Subject: Lake Powell Hydroelectric Project No. 12966
Response to Comments on the Draft Study Reports and Initial Study Report Meeting

Lake Powell Pipeline Project List of Draft Study Report Commenters and Abbreviations

Lake Powell Pipeline Project Responses to Participant Comments on Draft Study Reports

Chart 11

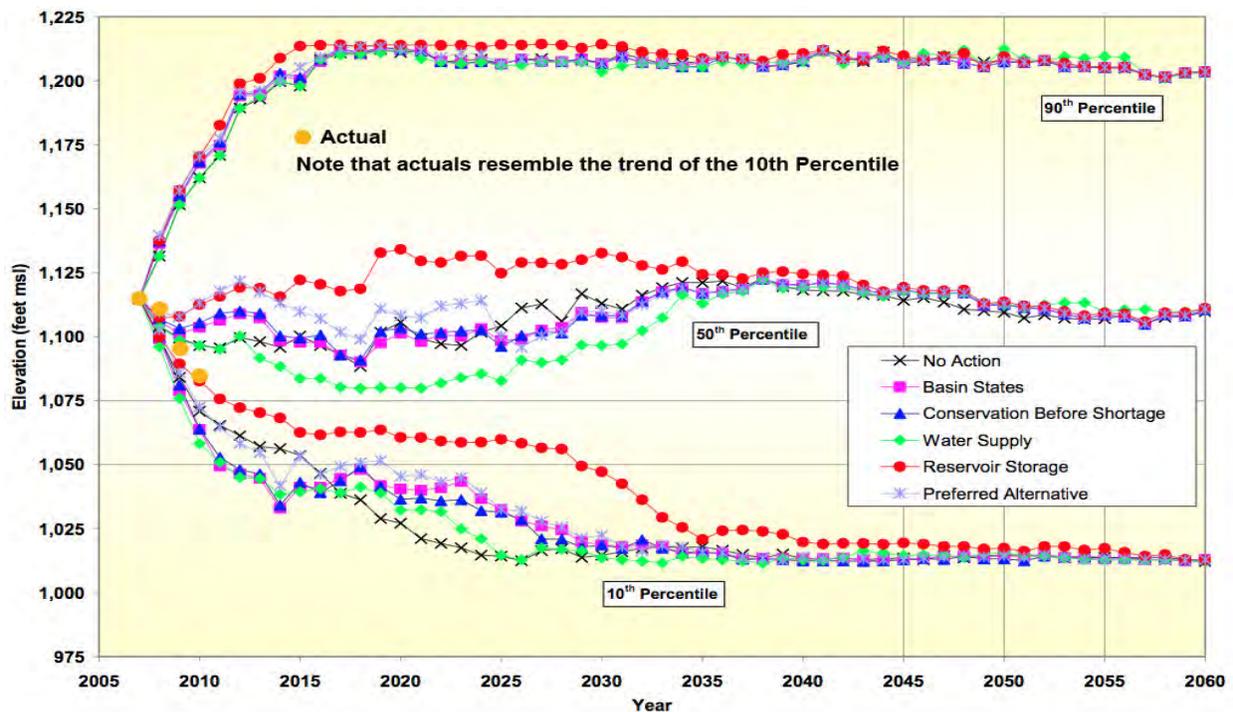
The model used for the Interim Guidelines predicted most probable 50th percentile and did not predict the fall of Lake Mead. The 10% percentile (minimum probable) correctly predicted the fall of Lake Mead. Using the 10th percentile as most probable is proving to be a better predictor of future conditions and could be used for a range of conditions to assess future environmental impacts on elevation and storage in Lake Powell.

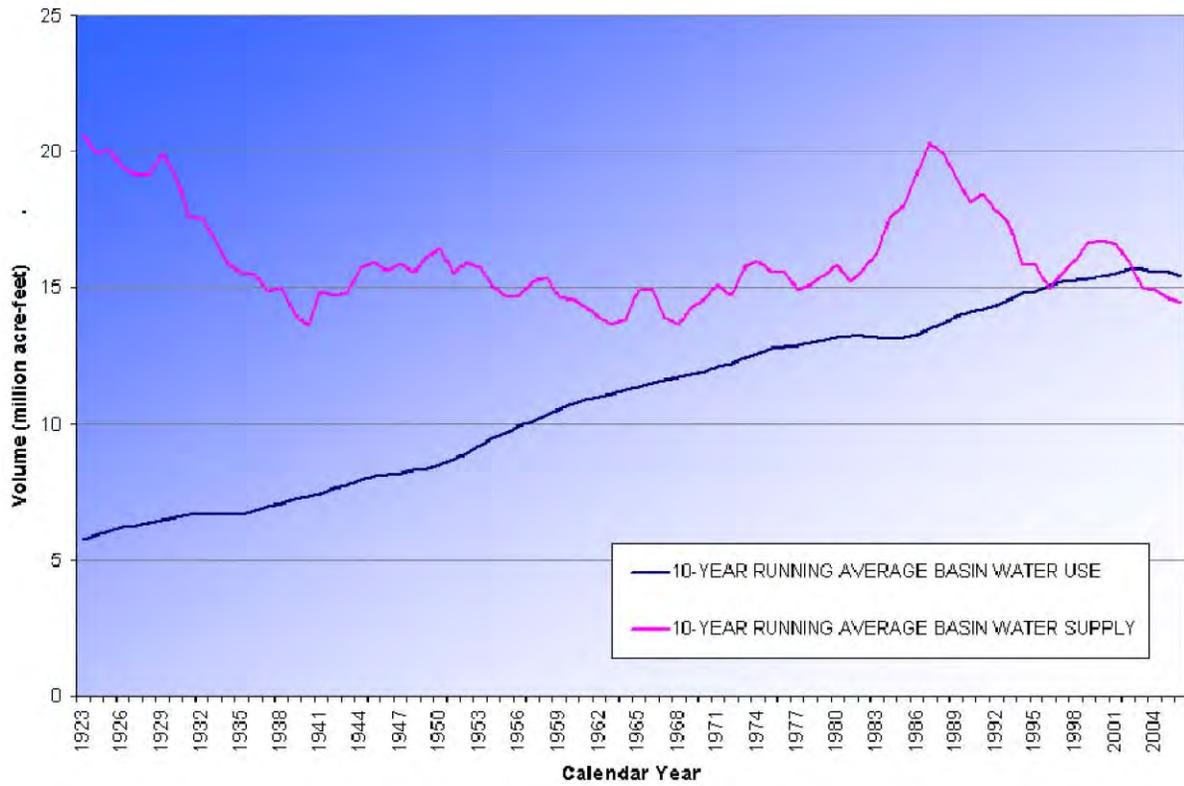
The Colorado River basin is ground zero for the hydrologic impacts of climate change. For years studies of climate change on global hydrologic patterns have predicted drier conditions in the desert southwest of North America (see IPCC, 2007). Recent improvement in the downscaling of global circulation models has led to greater specificity in the geospatial representation of results, and paved the way for assessing river system operations under climate change conditions. The Commission, as a federal agency with permitting authority for water resources development projects, has a special obligation to ensure use of the best available climate change science, as state and local agencies are typically not yet equipped to do so themselves.

Your comment has been noted.

Figure 2. Average annual total system hydrologic inflows for the Colorado River Basin through 2060

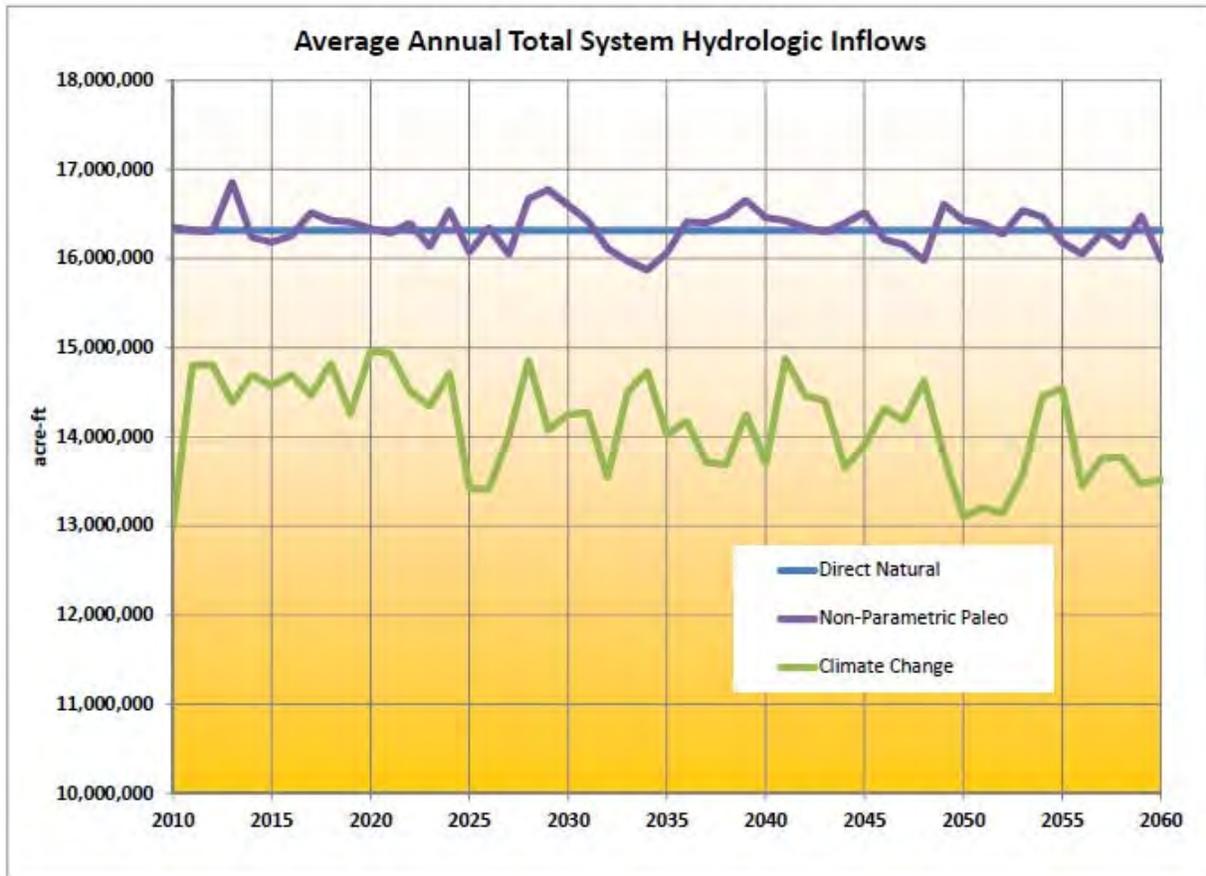
However, the study report fails to address an important corollary question: to what extent would limits on water supply in Lake Powell impact the physical ability of the Lake Powell Pipeline to deliver water? Chapter 4 of the same study report 19 assesses water availability in Lake Powell under two hydrologic scenarios, a) “direct natural” (projecting the 19062006 hydrologic record into

the future), and b) “nonparametric, paleoconditioned inflows” (projecting longterm past records of inflows, generated through study of tree ring records, into the future). Significantly, neither of these hydrologic scenarios is informed by climate change projections. Moreover, this analysis fails to address the finding reported earlier in the chapter that climate change impacts may cause Lake Powell to go dry. Figure 2, below, compares total basin inflows under three hydrologic inflow scenarios developed by Reclamation (direct natural, nonparametric paleoconditioned, and climate change) and demonstrates that the climate change flow scenario is considerably drier than either the direct natural or nonparametric paleoconditioned flow scenarios.

Figure 3. Projections under climate change scenario of the probability of Lake Powell falling below 3375 feet through 2060.

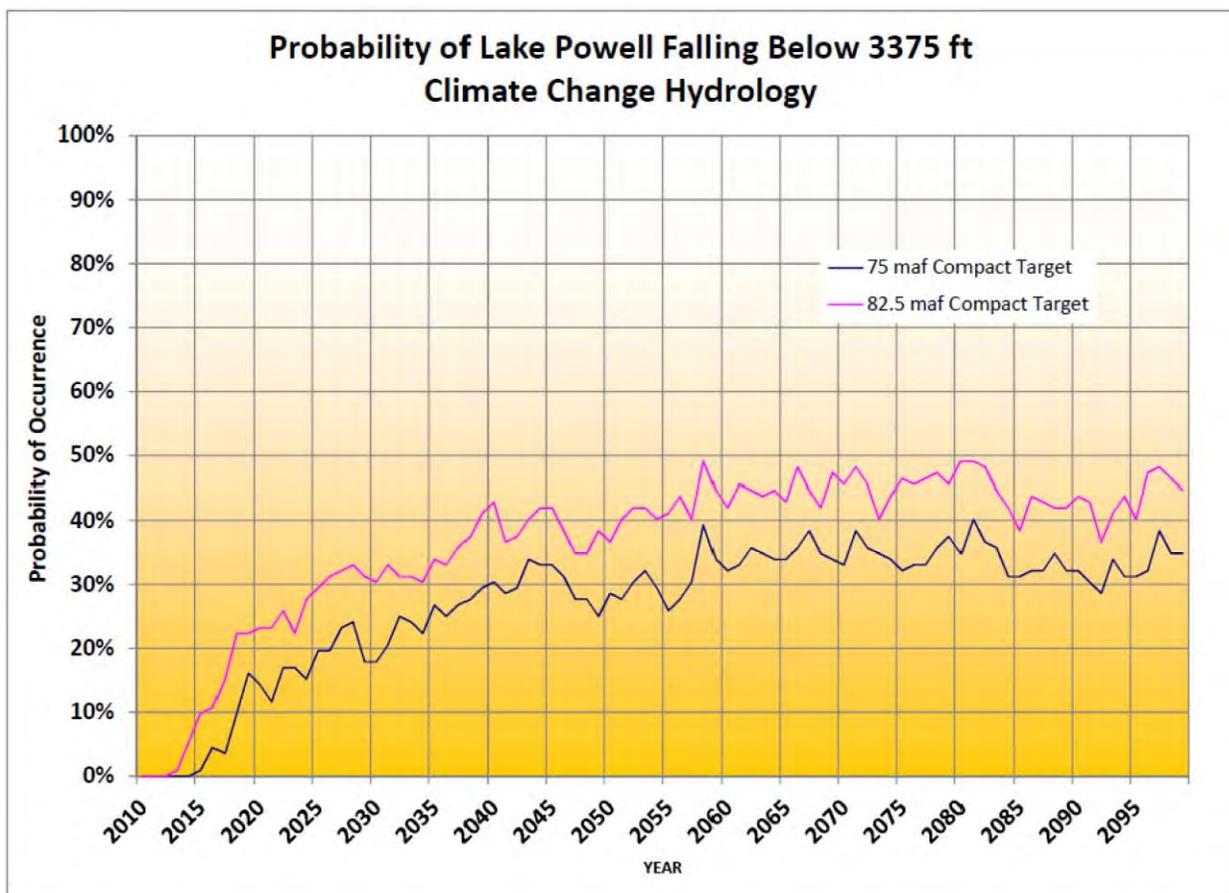
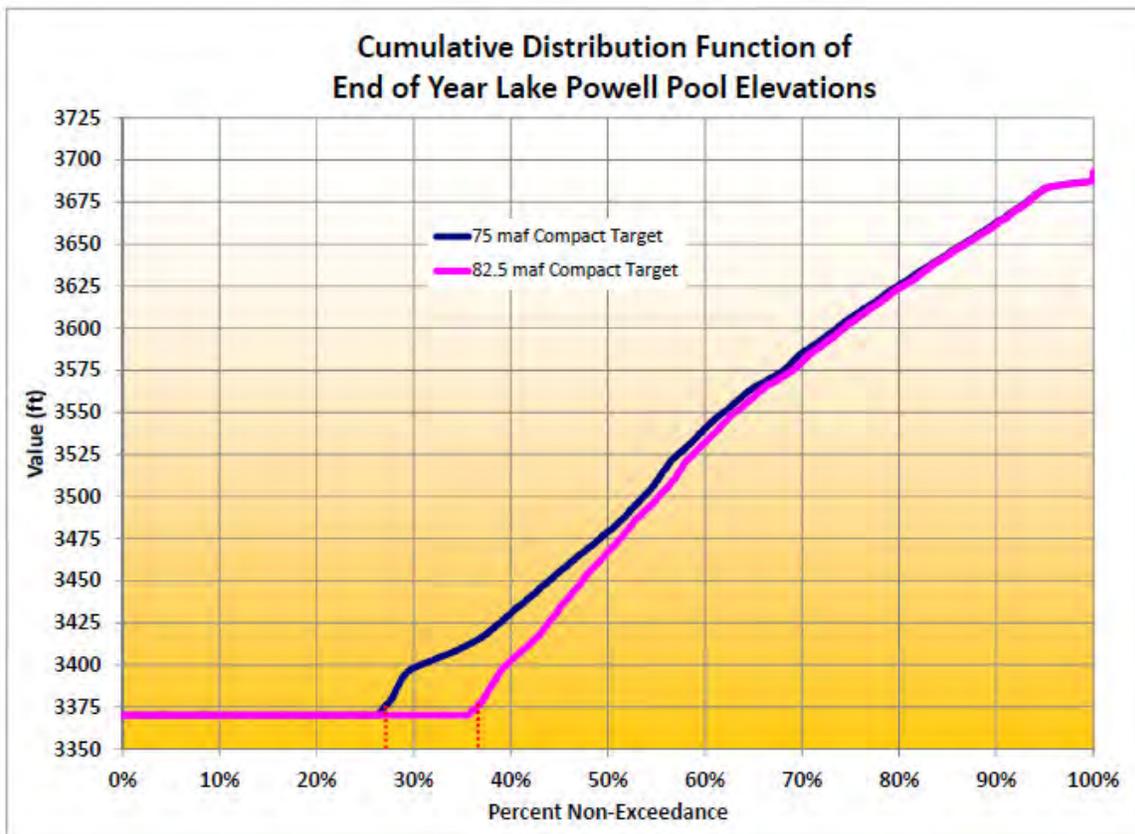
We prepared an independent CRSS analysis of Lake Powell water supply that uses a climate change inflow scenario similar to that published in Reclamation’s SECURE report, and assumes Compact deliveries at the 75 million acrefoot level. This analysis projects a 27% probability that the water surface elevation in Lake Powell would be below 3375 feet msl (the stated intake level for the proposed project) in any given year between 2010 and 2099 (see figures 3 and 4). If the compact delivery obligation is assumed to be 82.5 million acrefeet the probability of Lake Powell falling below 3375 feet msl increases to as much as 37%. We urge the Commission to require the project proponent, working with Reclamation, to replicate these analyses themselves. We urge the Commission to find that study report 19 has not been properly conducted because the analysis does not consider hydrologic conditions projected for the time period during which the project is proposed to be operational, and because the CRSS analysis used is flawed in that it does not demonstrate implementation of the Compact.

Figure N-10
End-of-December Elevations
Comparison of Single Trace using Nonparametric Paleo Conditioning with
Meko et al. Reconstruction for No Action Alternative (NA) and Preferred Alternative (PA)

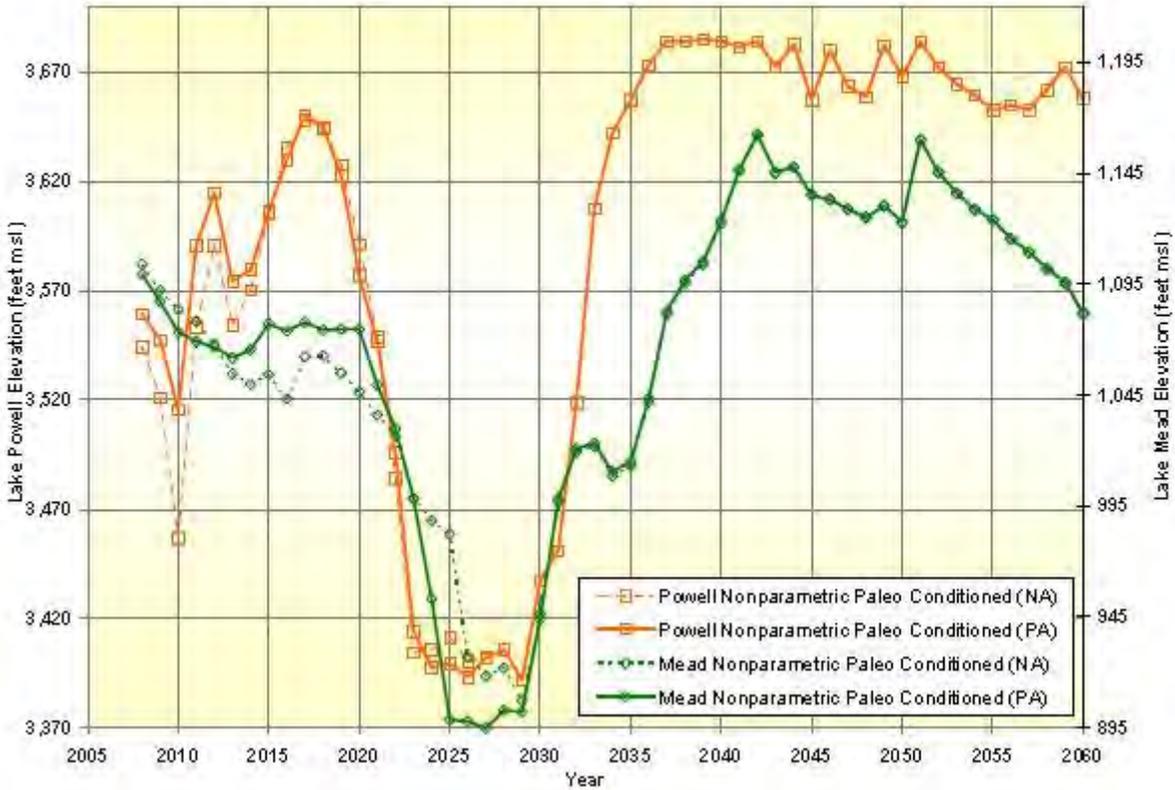
This chart shows drought occurring before 2055 as predicted in the report

Alternative includes absolute protection of Lake Mead at elevation 1,000 feet msl, which can result in shortages as large as 3,300 kaf which prevent the reservoirs from dropping to the elevations seen under the Preferred Alternative” as quoted from the text explanation of Figure N-10 in Appendix N of the Interim Guidelines FEIS.

Figure N-15
Lower Basin Shortages
Comparison of Direct Natural Flow Record to Meko et al. Reconstruction
No Action Alternative (NA) and Preferred Alternative (PA)
Probability of Occurrence

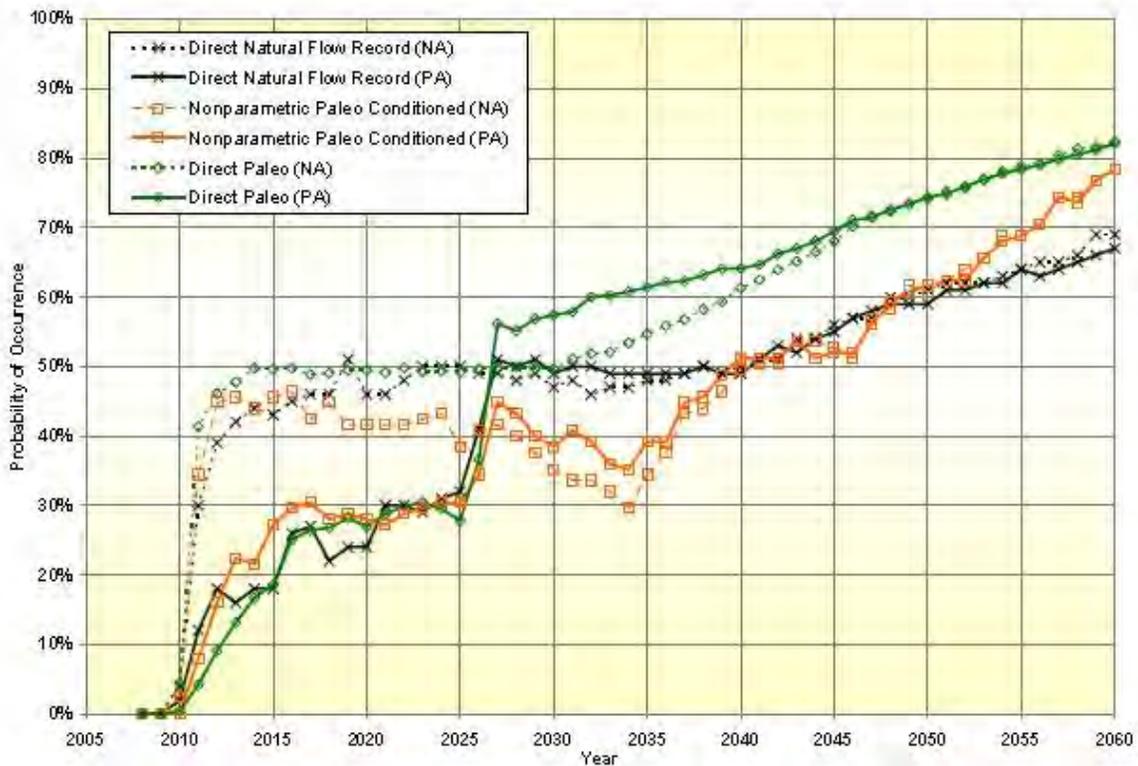
Interim Guidelines EIS 2007 Appendix N page N-23 Figure N-15, shows high probability of shortages in Lower Basin

The comment includes Figure N-15 and incorrectly interprets it as follows, stating: “...drought and shortage are predicted for the Lower Basin within 50 years term of the license and risk of shortage is why the Interim Guidelines were developed for the Lower Basin States.” This conclusion is drawn on Appendix N, which is introduced as “the analysis of the sensitivity of the hydrologic resources to alternative hydrologic inflow scenarios” as stated in Section N.1 Introduction, Appendix N. The draft study report text in Section 2.3 states: “These differences are noted in the sensitivity analysis, and the DNF hydrology was used for the modeling of alternatives in the final EIS.” The UDWR concludes that the review of the Interim Guidelines FEIS Hydrology as presented in the draft study report is correctly interpreted.

Figure 66. Change in percentage mean annual runoff distributed over the West.

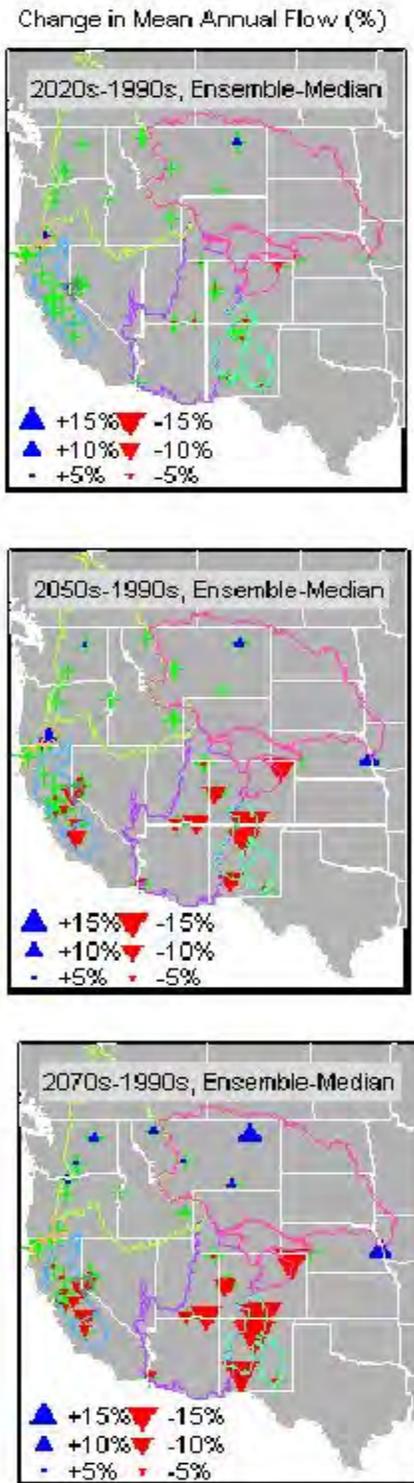
The chart below show predictions of lower flows for the Colorado River and should be included in this study report. The Applicant must include effects on resources and water availability over the term of license from 2020-2070 that include the estimated flow reductions of the Colorado River predicted in Reclamation’s new report. The Applicant must disclose these possible impacts of reduced flow in the study report so the Commission can make informed decisions on an adequate impact analysis and make a look before you leap approach.

The UDWR literature review summarized in the draft study report complies with the approved study plan. Figure 66 from the 2011 Reclamation Secure Water Act section 9503 (c) Report, incorporated into the comment, is accompanied by the following text: “Changes in surface water runoff are more complex than projections of snowpack. Analyses of historical runoff suggest that any trends in annual or seasonal runoff are weak. Hydrologic analyses based on future climate projections suggest that geographic trends may emerge (figures 66 and 67). The Southwestern United States to the Southern Rockies may experience gradual runoff declines during the 21st century and the Northwest to north-central United States may experience little change through the mid-21st century with increases projected for the late 21st century (figure 66).” The introduction to the West-wide Summary of Hydroclimate Changes section (which includes figure 66) of the 2011 Reclamation Secure Water Act Section 9503 (c) Report states: “It is noted that these summary statements reflect regionally averaged changes and that projected changes have geographic variation; they vary through time; and the progression of change varies among climate projection ensembles...” The comment misrepresents the 2011 Reclamation Secure Water Act Section 9503 (c) Report regarding snow water equivalent: “Snow water equivalent will be down by 50% in 2020, down by 60% by 2050, and down by 66% in 2070.” Section 2.4.1 of the report summarizes climate and hydrologic changes in Table 1, which reflect a subbasin-average view and measured relative to 1990s baseline conditions. The summary of simulated changes in decade-mean hydroclimate for the Colorado River at Lees Ferry subbasin in Table 1 shows the mean April 1st snow water equivalent (percent) as -50.0 in the 2020s, -60.6 in the 2050s, and -66.9 in the 2070s. The comment incorrectly assumes a 50 year license period, which has not yet been determined by FERC.

Figure 1. Residential building permits in Washington County.

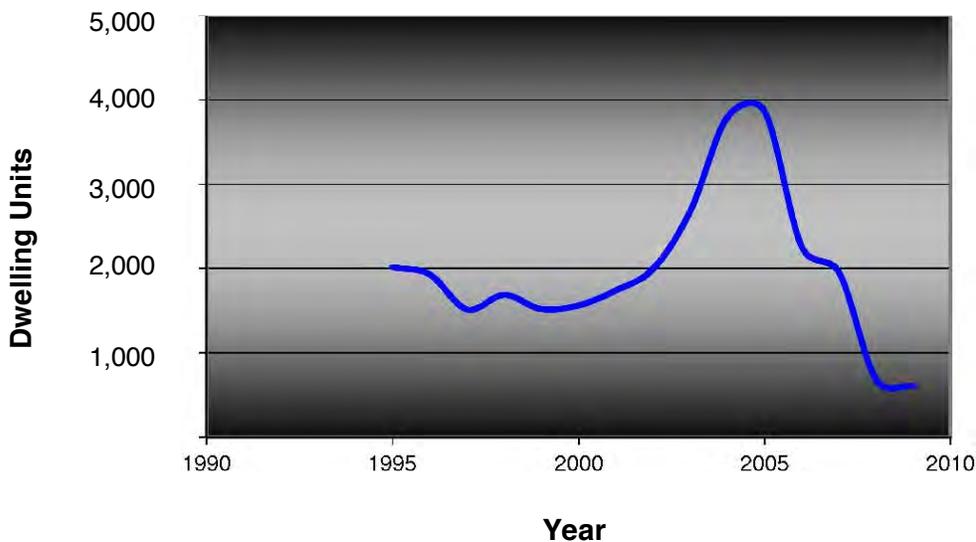
Population projections are heavily dependent on the initial estimate of population and the rate of population growth, where errors in the first few years are compounded greatly over time. The current economic slowdown in Utah will play a significant role in reducing estimated future water demands by decreasing population growth rates over the next few years. Importantly, foreclosures in Washington County are the second highest in the state (1 in every 168 homes) and building permits have decreased precipitously since 2005 (Figure 1), strongly indicating that future growth rates should be much lower than those projected in the WNA. Future demands will not be as high as currently projected, even if growth continues at the expected rate ten or more years from now, because growth is held up at this time.

Figure 2. Marginal Price Curve of Water Rate Structures for Southwest Communities.

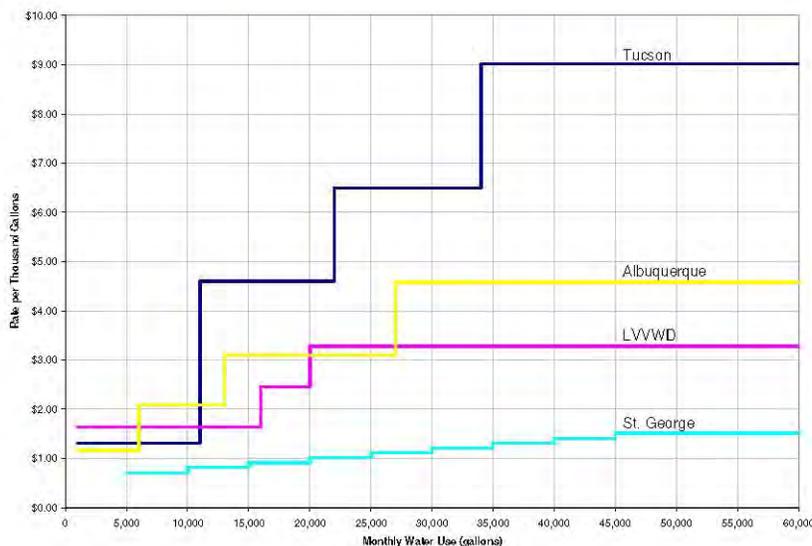
16. As one local example, St. George’s increasing block rate structure does not provide an adequate conservation price signal (Figure 2). Because the price differential between blocks in St. George’s water rate structure is small and the fixed price is high, customers receive no financial signal when they consume excessive amounts of water. This is in direct contrast to customers in Tucson or Albuquerque which see the average price of water increase dramatically as their water use increases.
